NUCLEAR FUEL SERVICES, INC.

Pursuant to Paragraph 50.59 of Title 10 Code of Federal Regulations, Nuclear Fuel Services, Inc. hereby requests a change in Technical Specifications for Operating License CSF-1. The proposed changes will permit the NFS Processing Plant at West Valley, New York to transfer to process and process plutonium nitrate-uranyl nitrate solutions such as now being prepared at the NFS facility at Erwin, Tennessee. The Division of Material Licensing previously approved receipt and storage of such material by Change No. 14 of the Technical Specifications of License CSF-1. The safety evaluation of the proposed processing plan and the proposed changes to the Technical Specifications are attached.

SAFETY EVALUATION
TRANSFER AND PROCESSING OF PLUTONIUM
NITRATE-URANYL NITRATE SOLUTIONS

TYPICAL PLAN VIEW
DISSOLVER BASKET BARREL

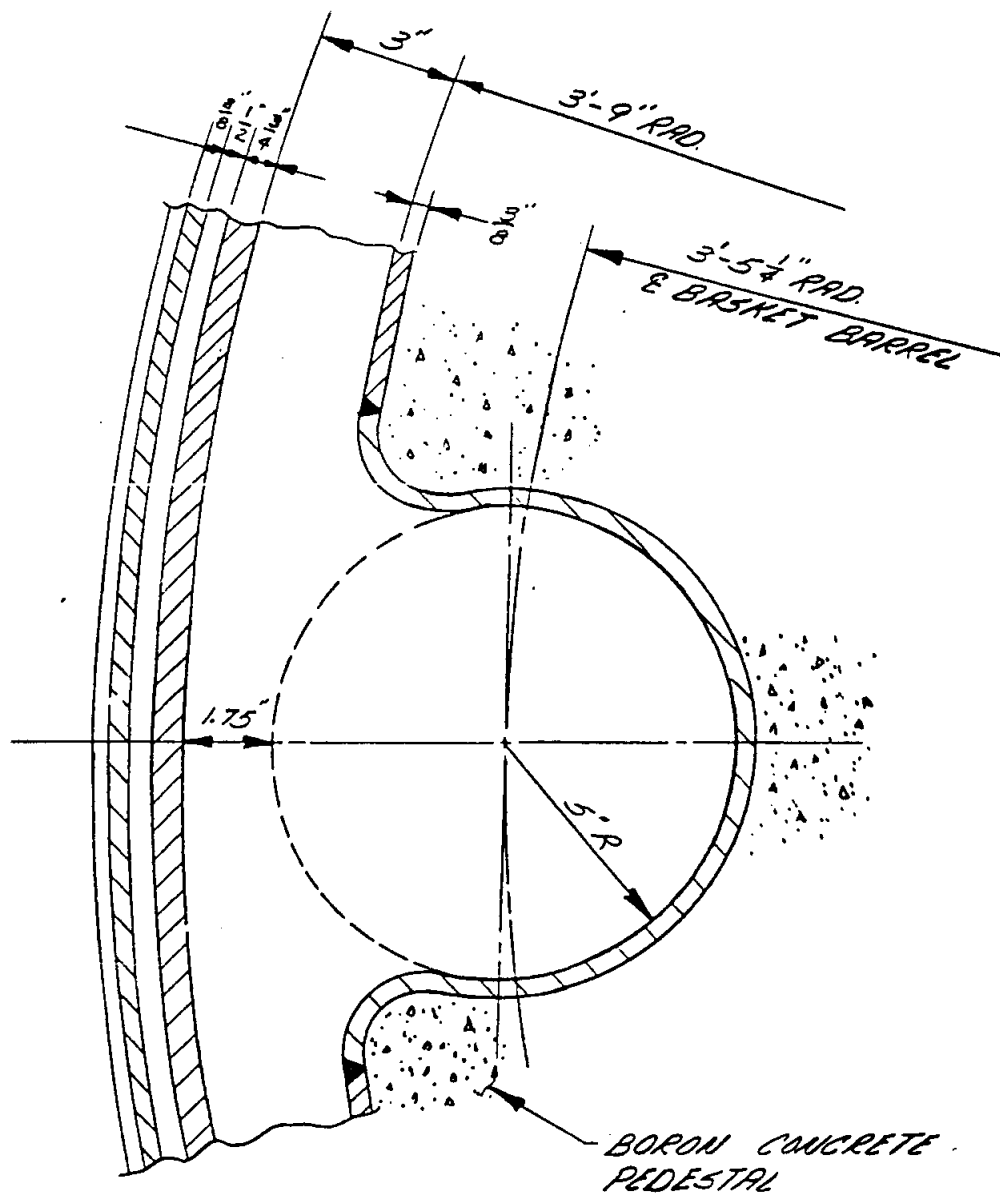
The dissolver barrels have a 10-inch diameter but, as shown on the attached plan view of a dissolver barrel, the effective diameter is somewhat larger due to the 3-inch annulus. Using the longest diameter of 17 inches, assuming symmetry which does not exist and neglecting the neutron absorption in both the uranium and the nitric acid, the minimum critical concentration computed from ARH-600 for an infinite cylinder is

7. Provide additional information concerning the concentration limits for the dissolver. This presentation should include an analysis of the effect of the intersection of the three inch dissolver annulus with the dissolver barrels.

FIGURE 4.4.1

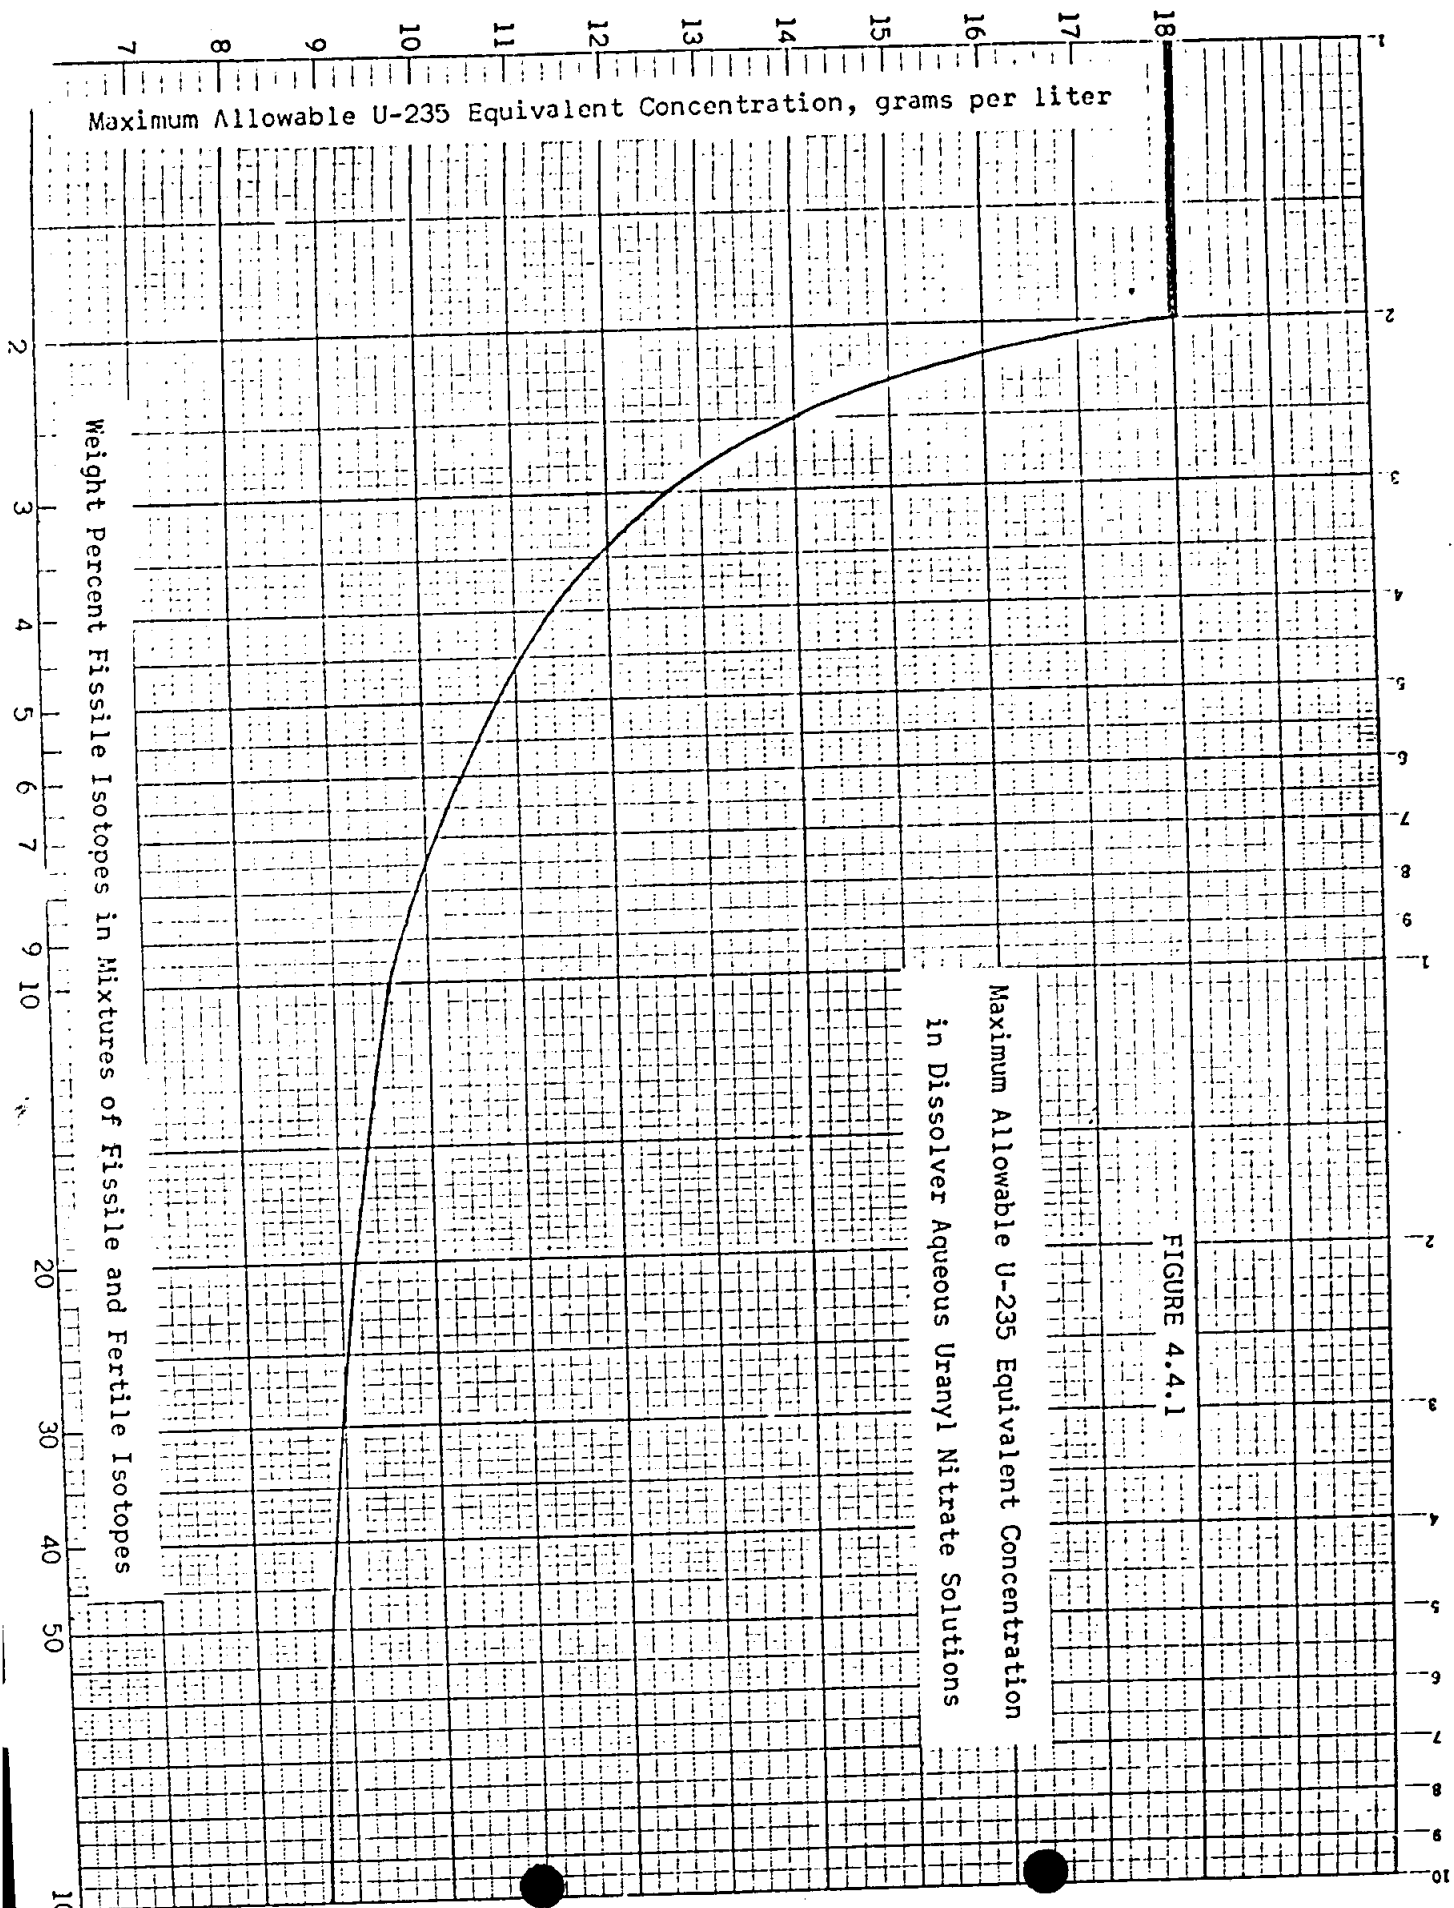
2. Modify the terminology of Figure 4.4.1 so that a) the ordinate reads "Maximum Allowable U-235 Equivalent Concentration, grams per liter" and b) the abscissa reads "Weight Percent Fissile Isotopes in Mixture of Fissile and Fertile Isotopes".

4.4.2 THE MODE OF CHARGING DISSOLVENT SHALL BE SUCH THAT THE RESULTANT AVERAGE U-235 EQUIVALENT CONCENTRATION SHALL NOT EXCEED THE VALUES SHOWN IN FIGURE 4.4.1. THE U-235 CONTENT OF THE CHARGED FUEL SHALL BE ASSUMED TO BE THE U-235 CONTENT OF THE FUEL PRIOR TO IRRADIATION, EXCEPT THAT

Maximum Allowable U-235 Equivalent Concentration
in Dissolver Aqueous Uranyl Nitrate Solutions

FIGURE 4.5.1

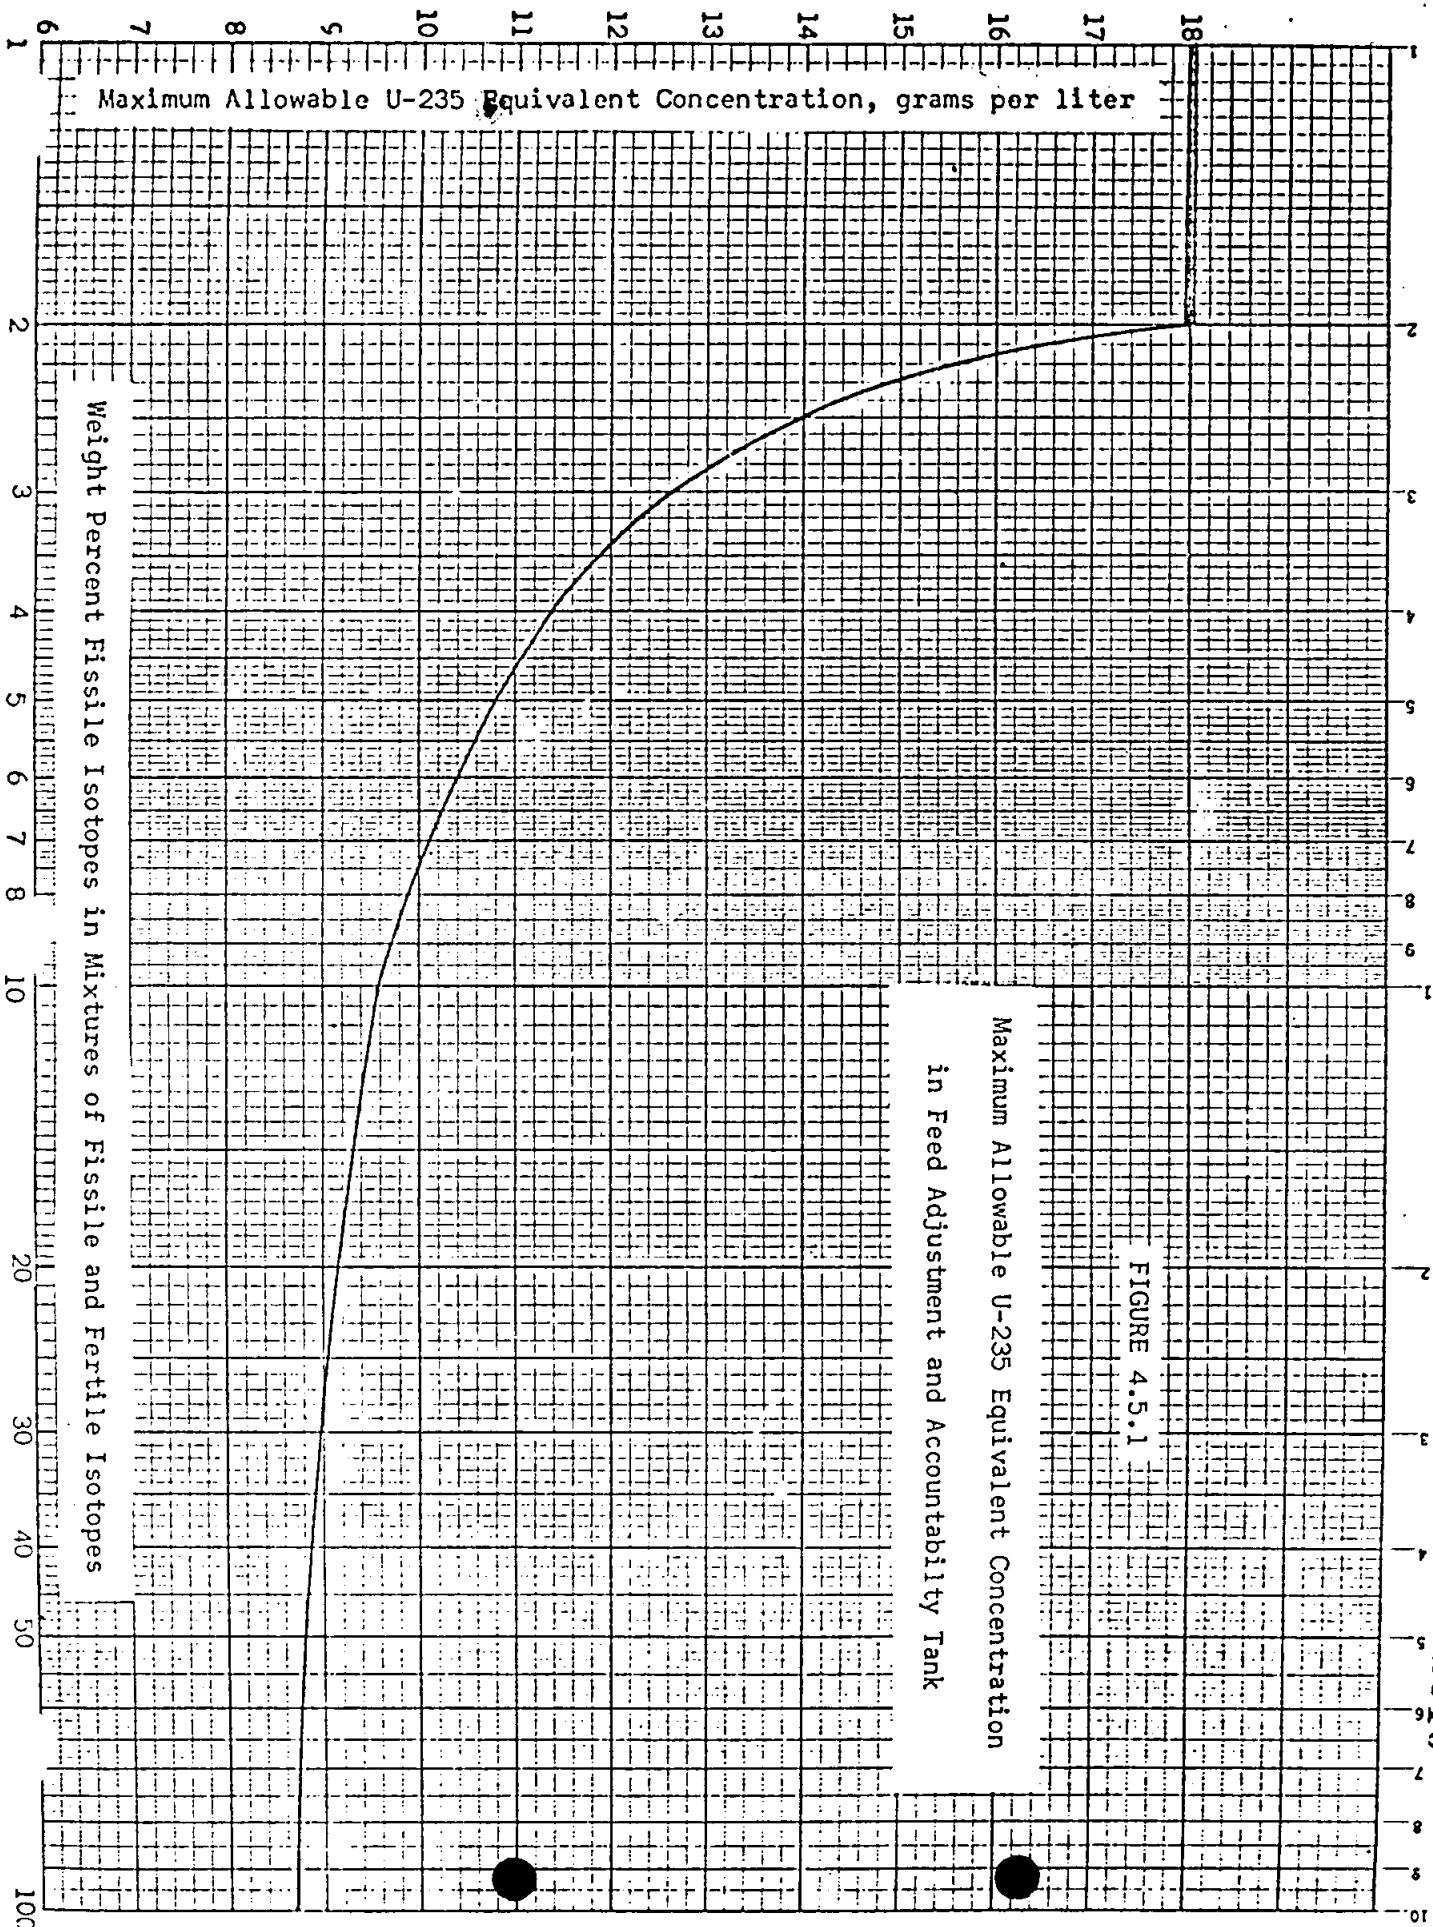
4. Modify the terminology of Figure 4.5.1 so that a) the ordinate reads "Maximum Allowable U-235 Equivalent Concentration, grams per liter" and b) the abscissa reads "Weight Percent Fissile Isotopes in Mixture of Fissile and Fertile Isotopes".
5. Remove the last sentence of the first paragraph of the Bases of Specification 4.5.

4.5.1 THE CONCENTRATION OF FISSILE ISOTOPES IN THE FEED ADJUSTMENT AND ACCOUNTABILITY TANK SHALL NOT EXCEED, AFTER ADJUSTMENT, THE U-235 EQUIVALENT CONCENTRATION SHOWN IN FIGURE 4.5.1, BASED UPON FUEL ENRICHMENT PRIOR TO IRRADIATION, EXCEPT THAT

The concentration limits defined by Figure 4.5.1 are 70% of the calculated critical concentrations reported in ORNL-TM-686, Limiting Critical Concentrations of Aqueous Nitrate Solutions of Fissile and Fertile Isotopes. To take into account variance in analytical and instrumentation data used in determining concentrations, three standard deviations in the conservative direction will be applied to the data.

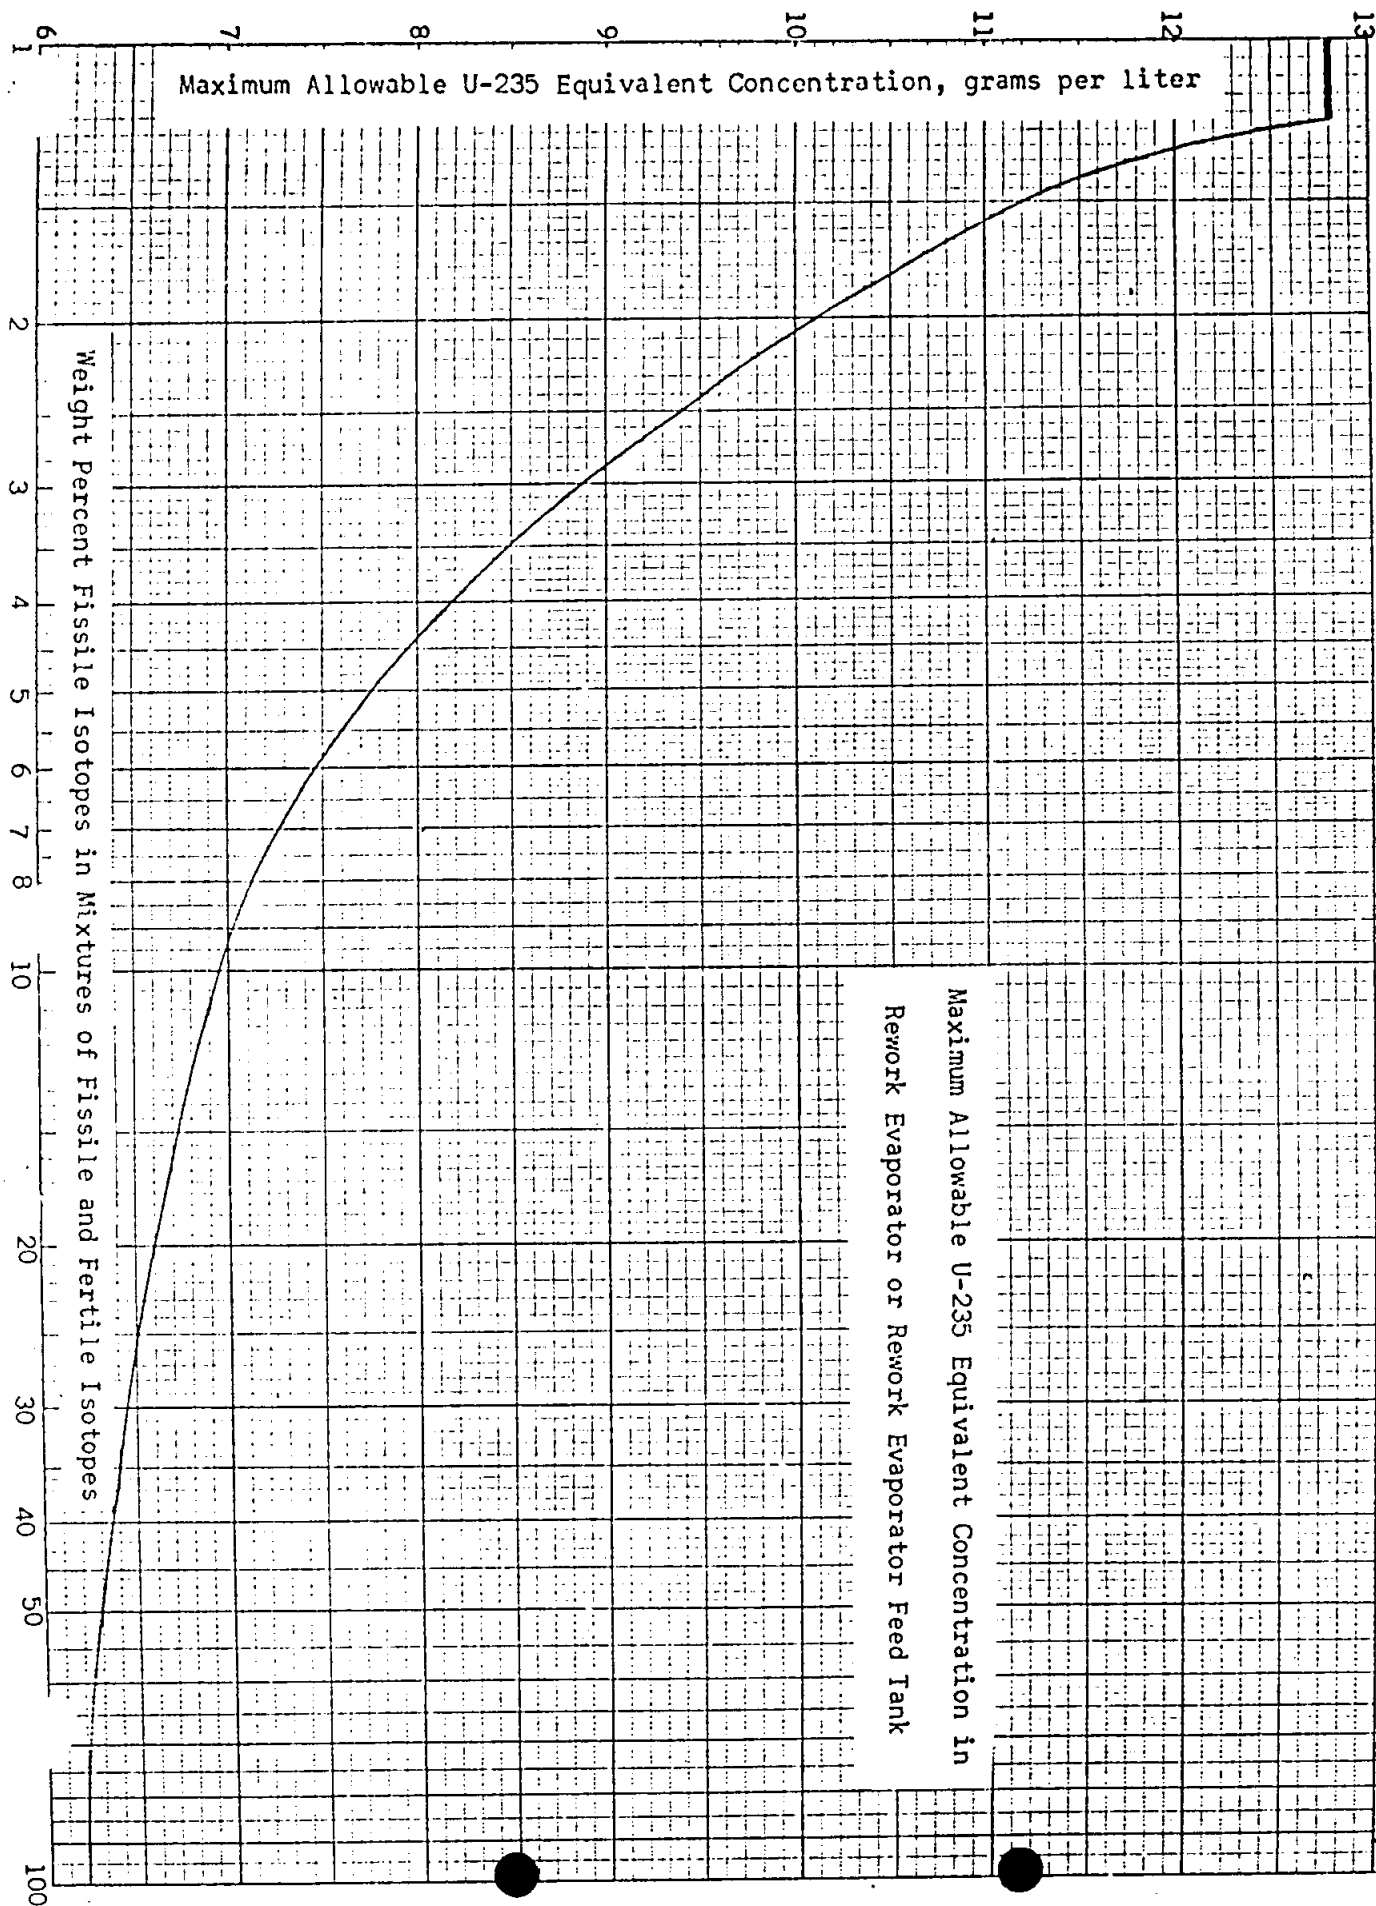
A change to Technical Specification 4.11 Rework Solution Concentration was previously proposed and is attached here to be consistent with the changes proposed for Technical Specifications 4.4 and 4.5.

4.11.1 THE CONCENTRATION OF FISSIONABLE ISOTOPES IN THE REWORK EVAPORATOR AND THE REWORK EVAPORATOR FEED TANK SHALL NOT EXCEED THE U-235 EQUIVALENT CONCENTRATIONS SHOWN IN THE ACCOMPANYING CURVE.
